ADDENDUM NO. 1

Date: **February 9, 2024**
Issued by: **Sacramento City Unified School District**
Project: **Project #0410-409-1 Albert Einstein MS Modernization**

14 METAL EDGING DETAIL

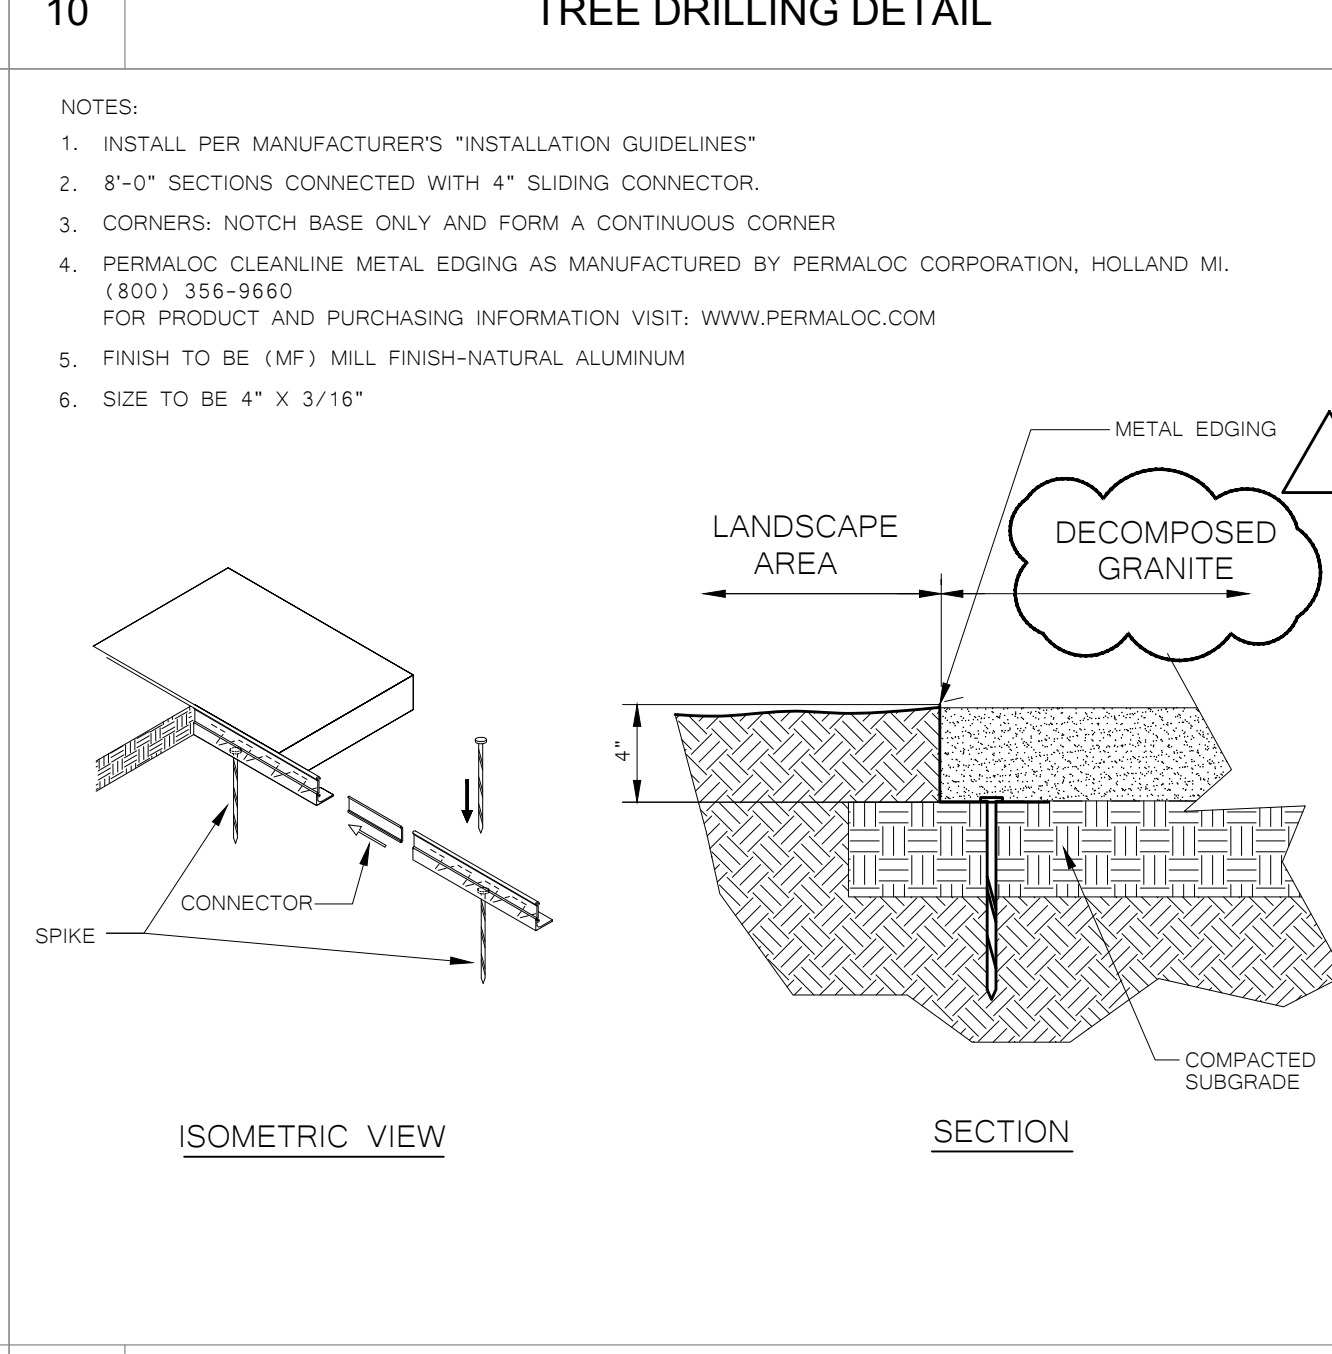
Q#19: Bid Package A – Please provide size of redwood header board at decomposed granite per detail 9/L410. What is Redwood size 2" x 4" or 2" x 6"?
R#19: *See detail 14/L410 on AD01.12*

PARKING LOT TREE PLANTING PLAN

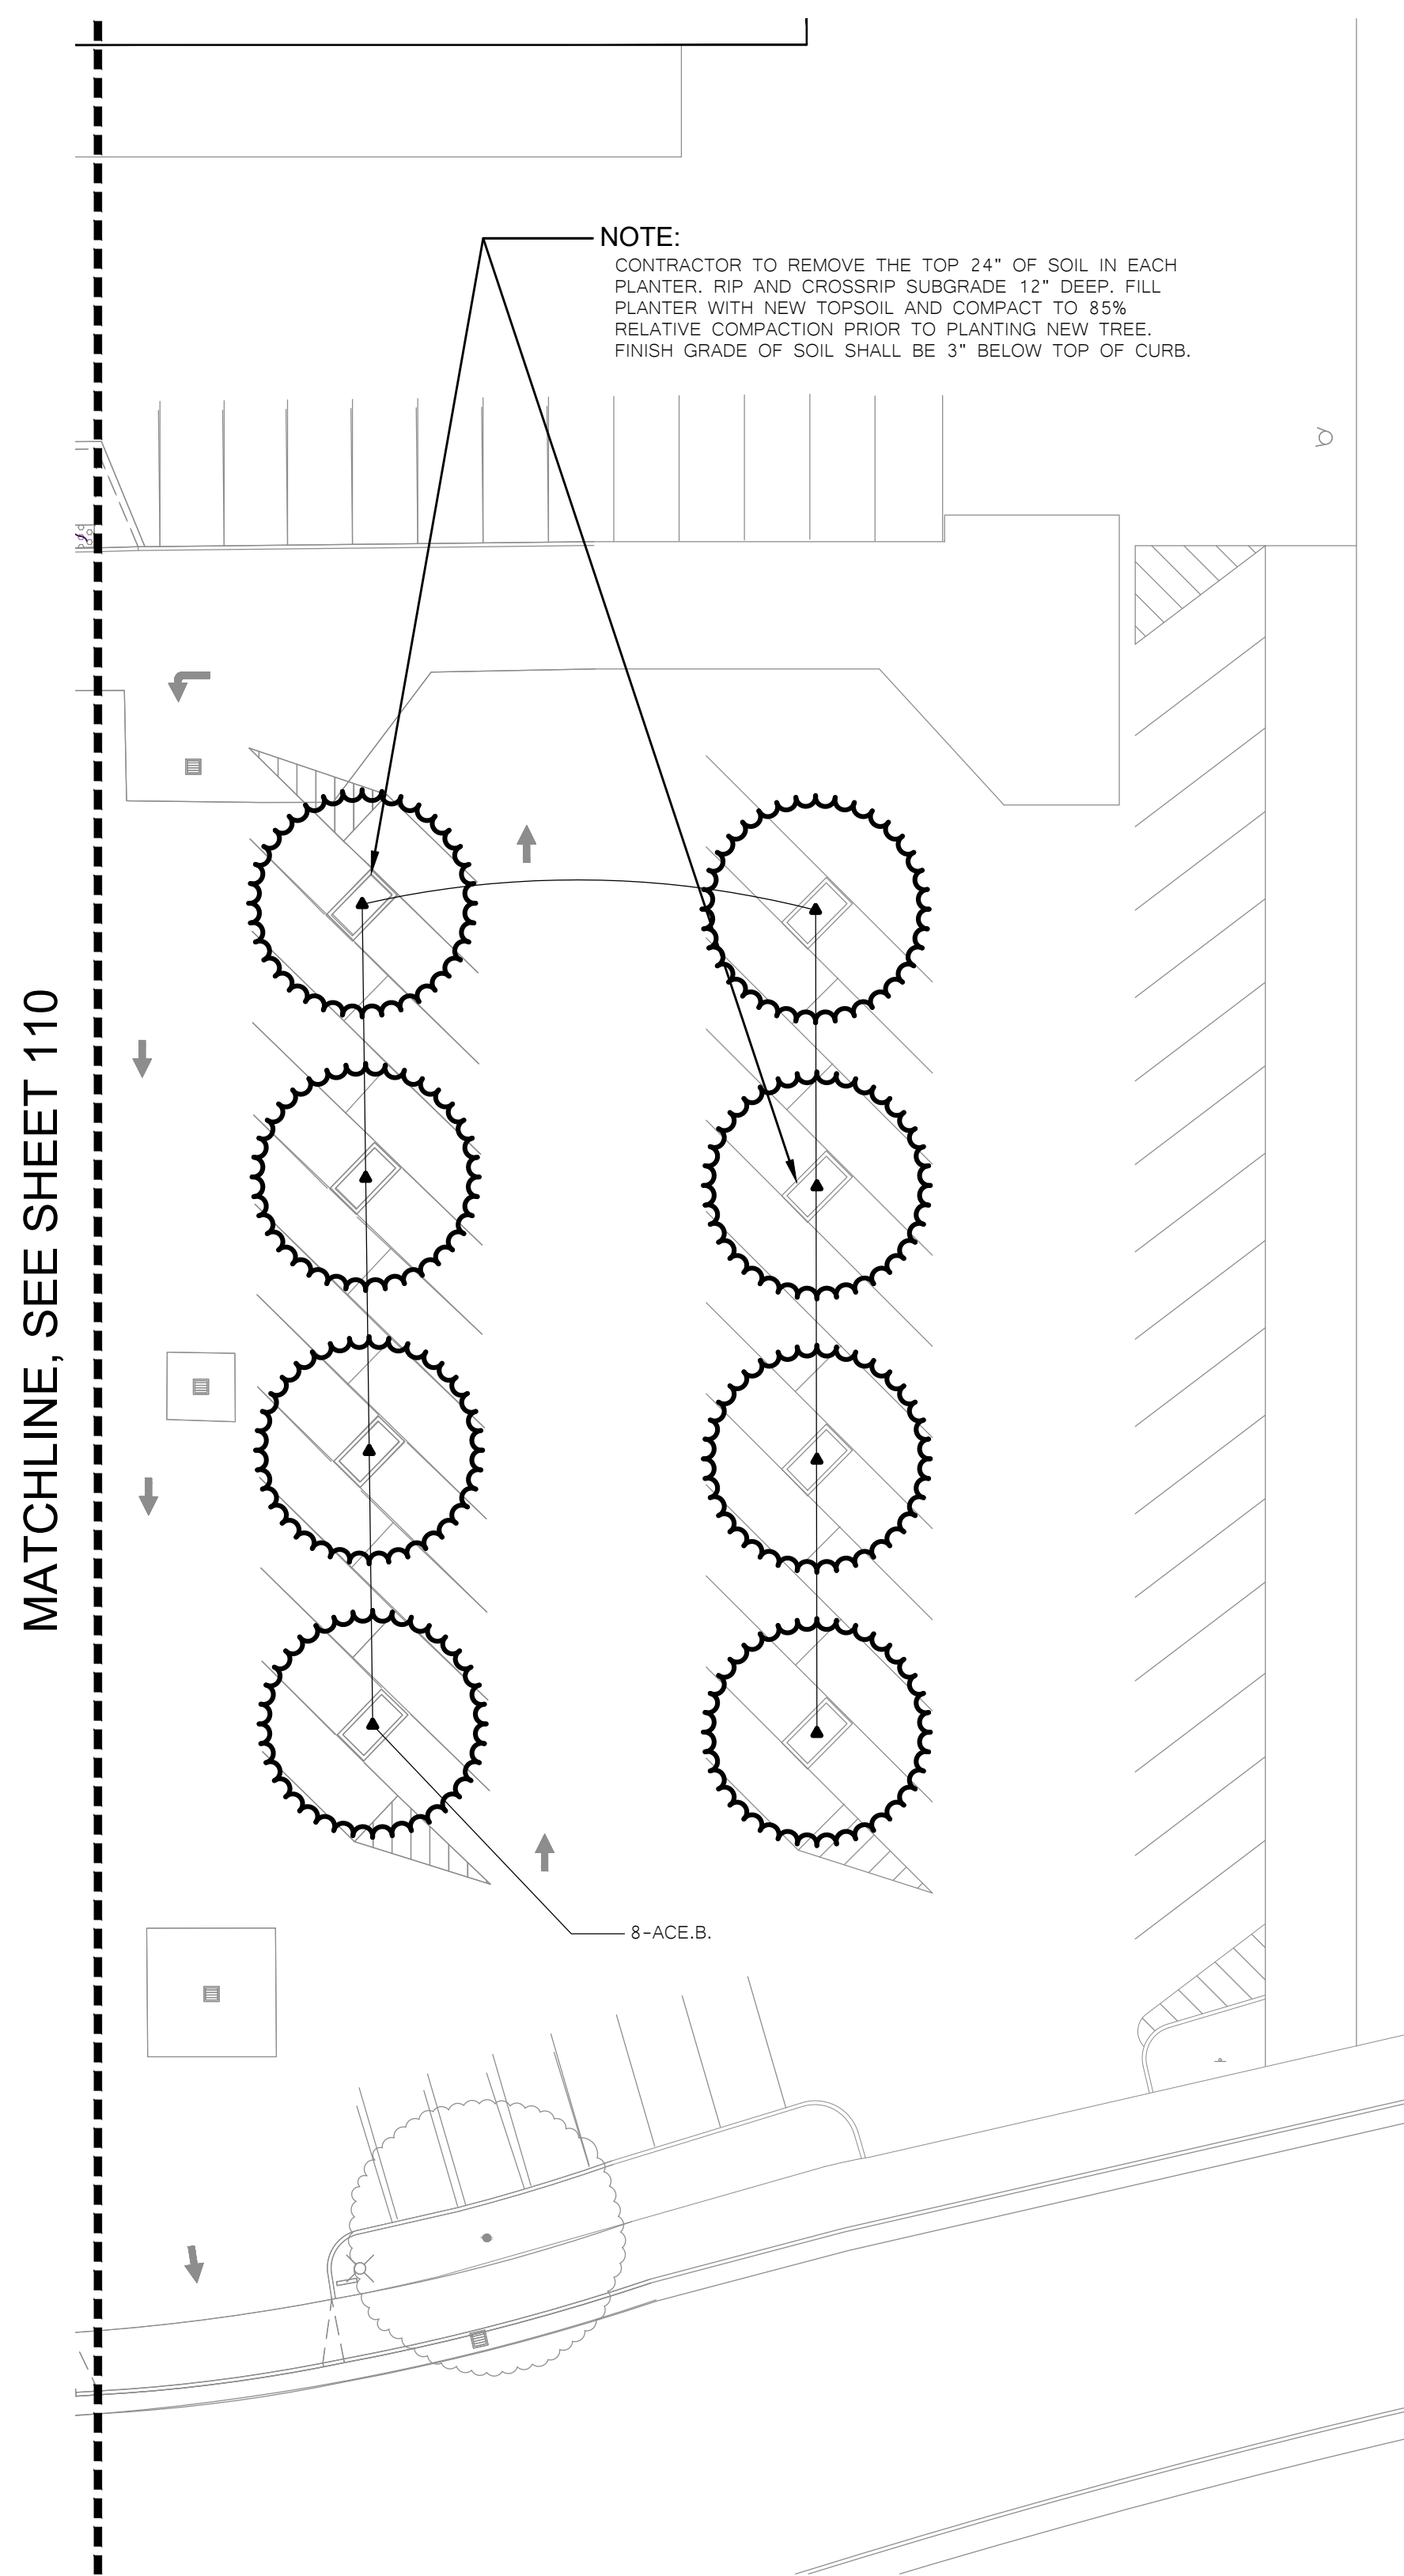
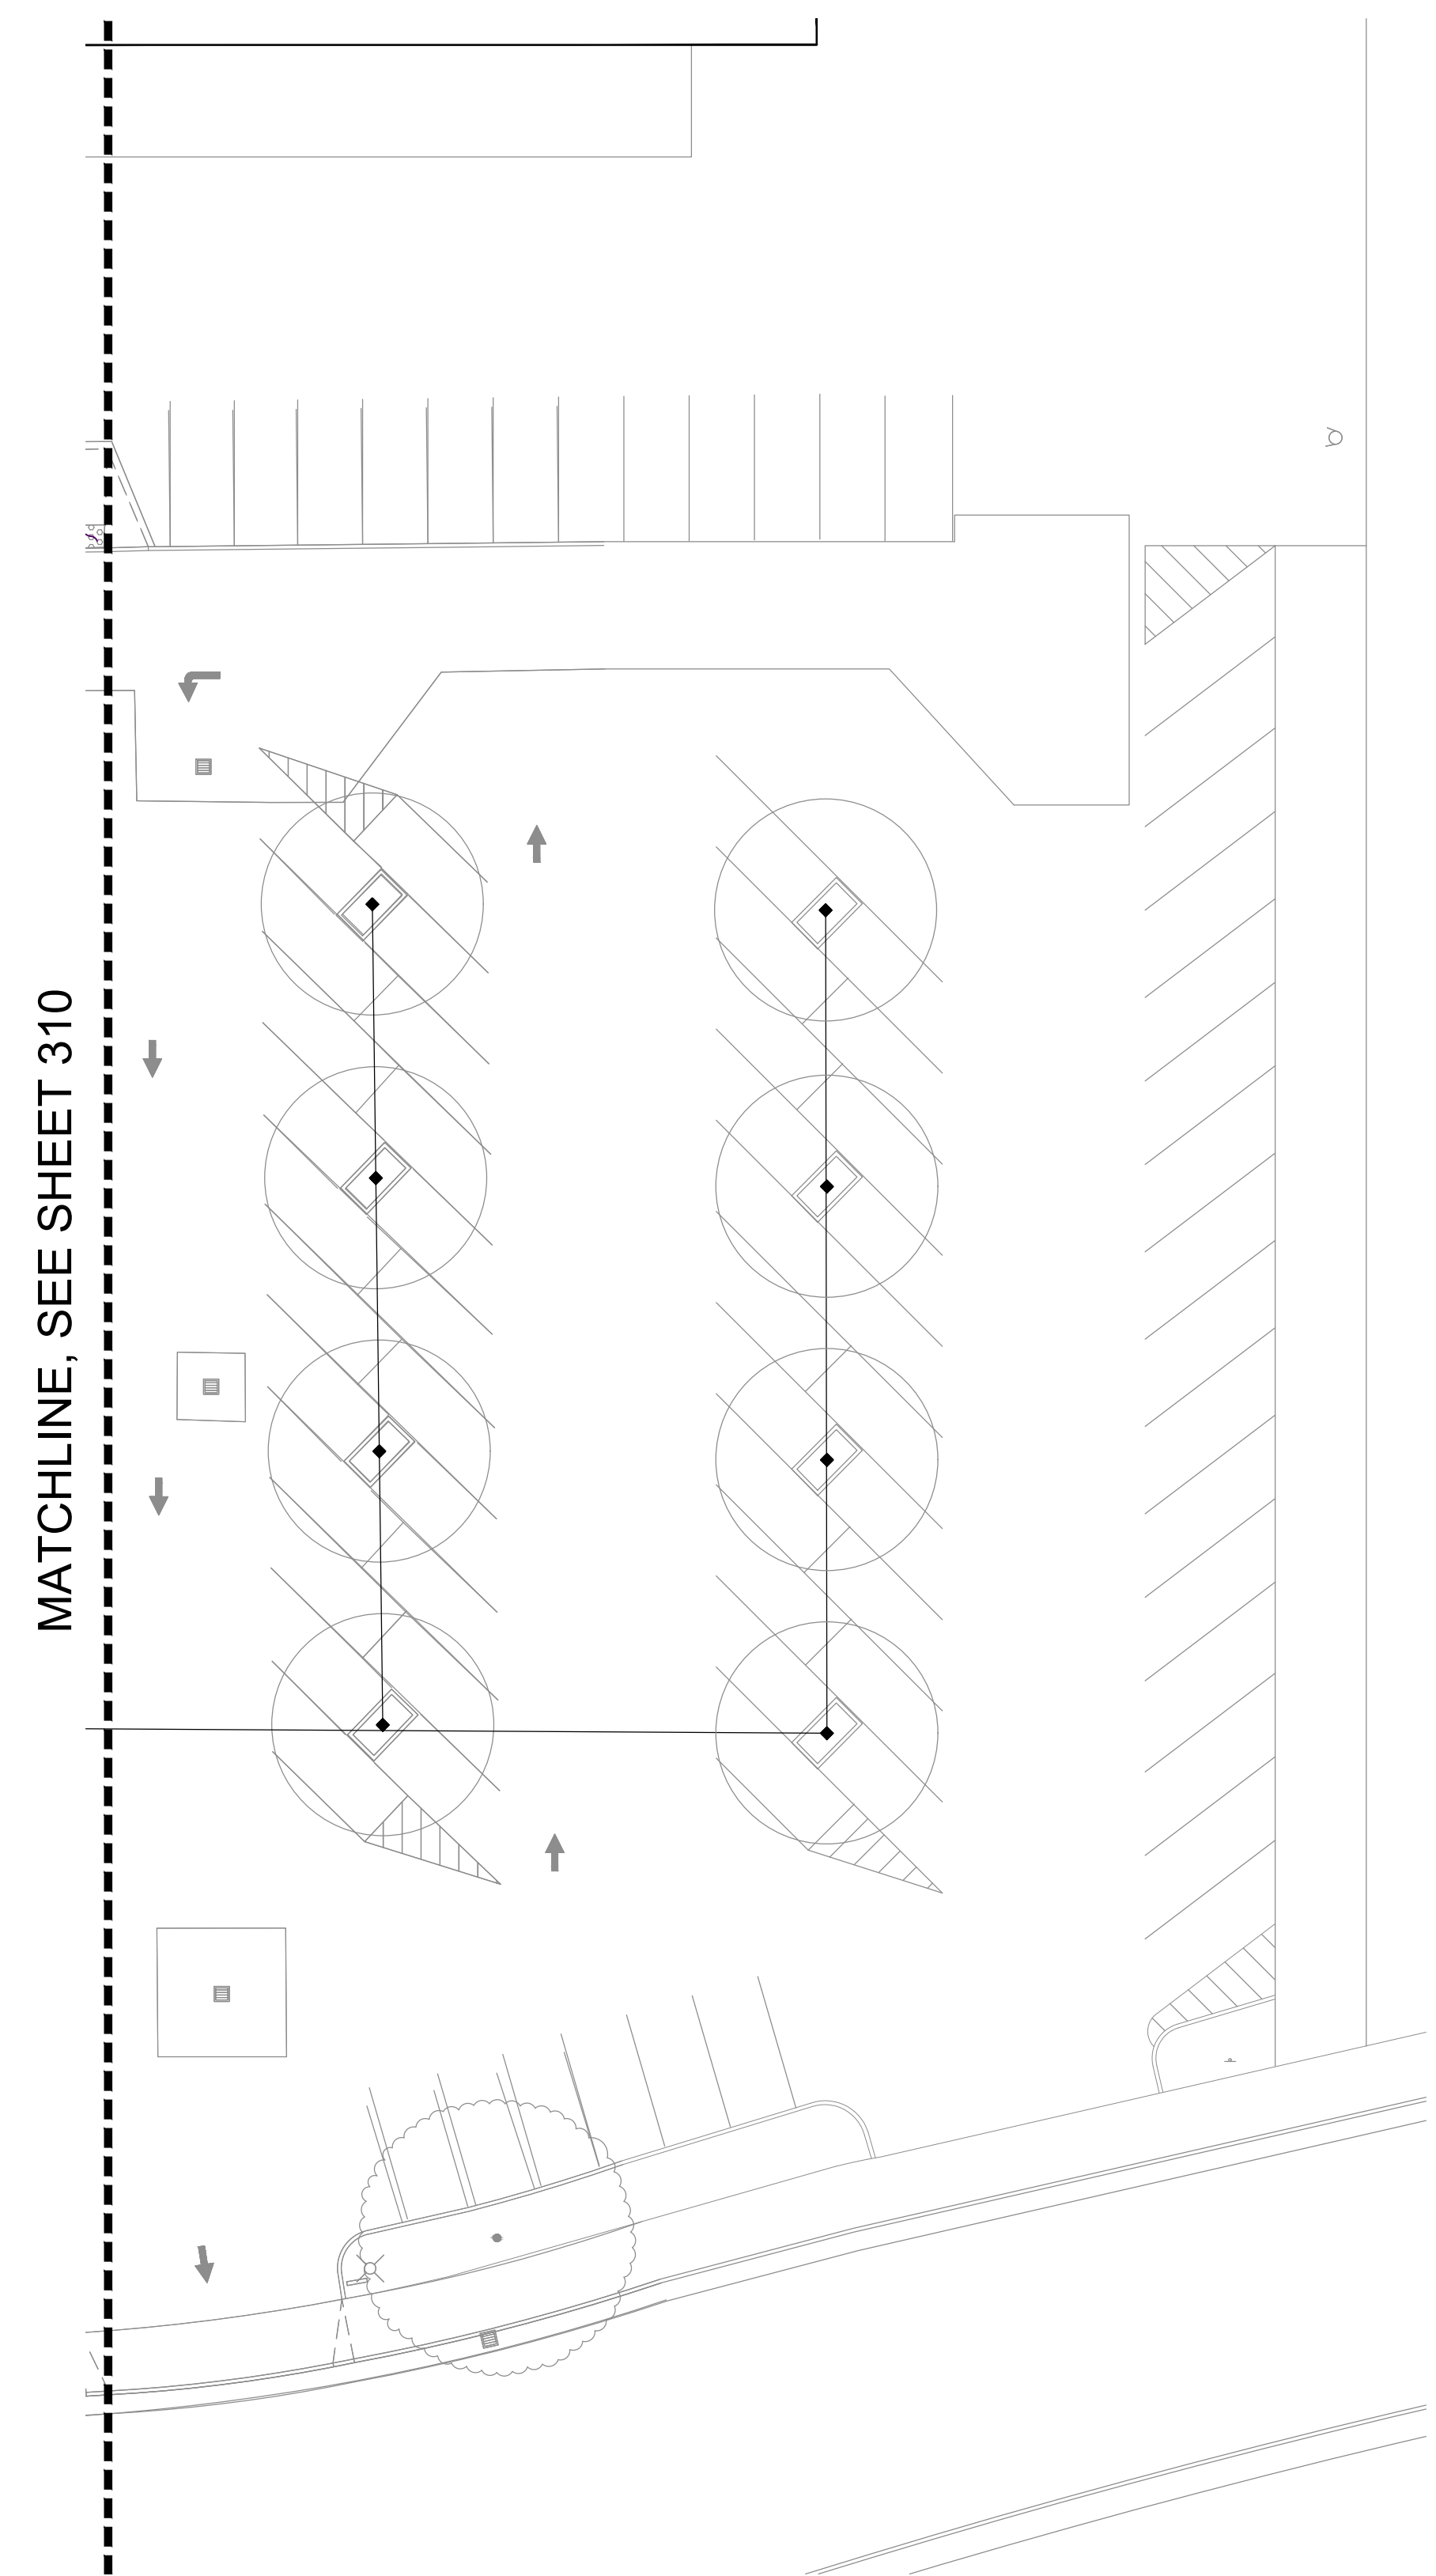
Addendum Item No. AD1.14- L610 Parking Lot Tree Planting and Irrigation Plan (Package A)

- Insert entirely new sheet per addendum drawing number AD01.14. Trees at parking lot planters now shown. Revise Table of Contents to reflect new sheet. Coordinate with Civil for additional demo for the Parking Lot Landscape Irrigation Plan, water line shown diagrammatically.
